INITIAL FIRE SAFETY INSPECTION REPORT

Green Smart Shirts Ltd (Extension)

RSC ID: 24552

Date: 18th September 2023

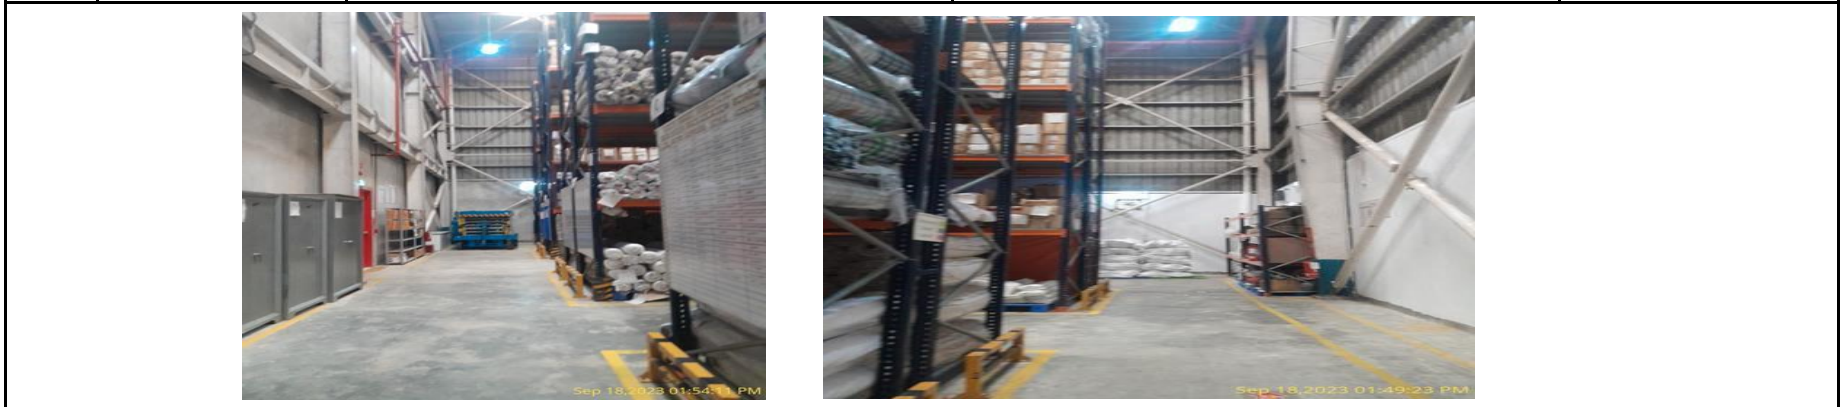
SI No.	Category	Findings	Required Action	Remediation Time Frame
F-1	Fire rated construction	Store room is not separated by fire rated construction due to unprotected opening & penetrations Location: Finished goods warehouse & Raw materials warehouse.	Enclose the storage area from the surrounding occupancy with a minimum 1 hour fire rated construction.	Within 3months
